City of Tampa Addendum

ADDENDUM 2

Contract: 25-C-00020; Sherwood Heights Pumpstation Force Main Relocation

# Sherwood Heights FM FDEP Permit Drawing

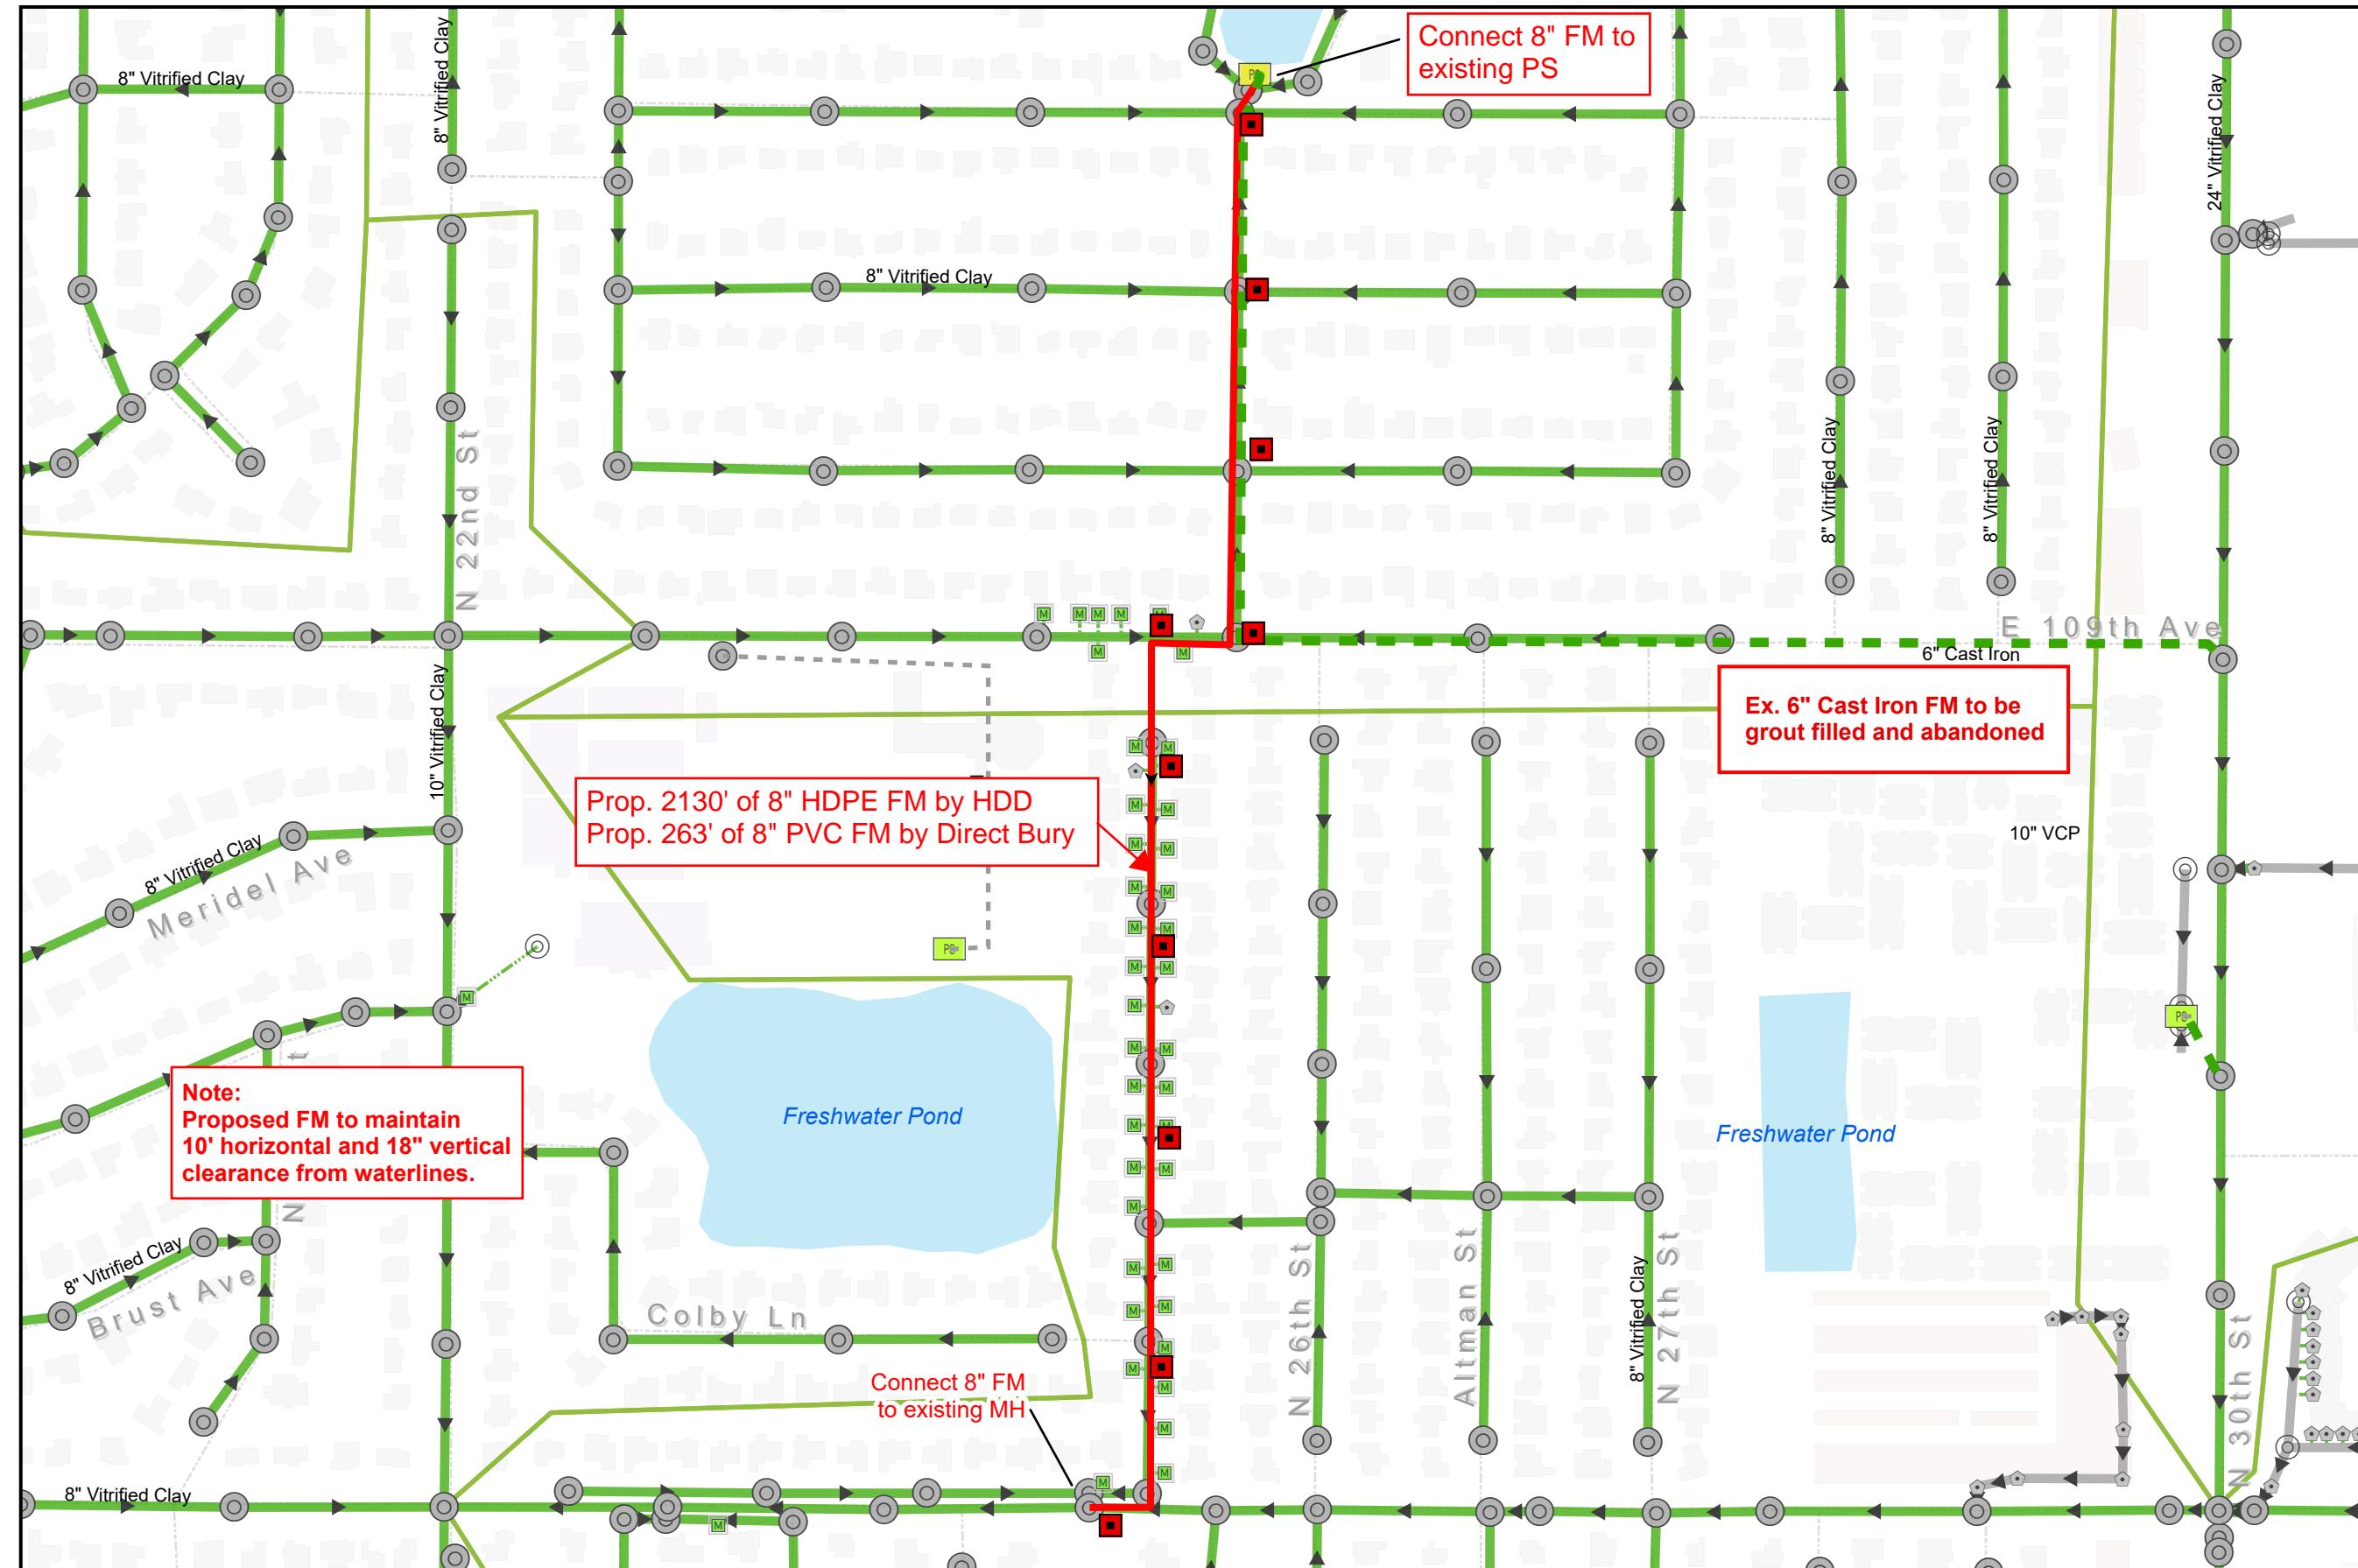
Item 2 – Add a plan sheet 1a to the plan set which includes the map attached “Sherwood FDEP map – sheet 1a”
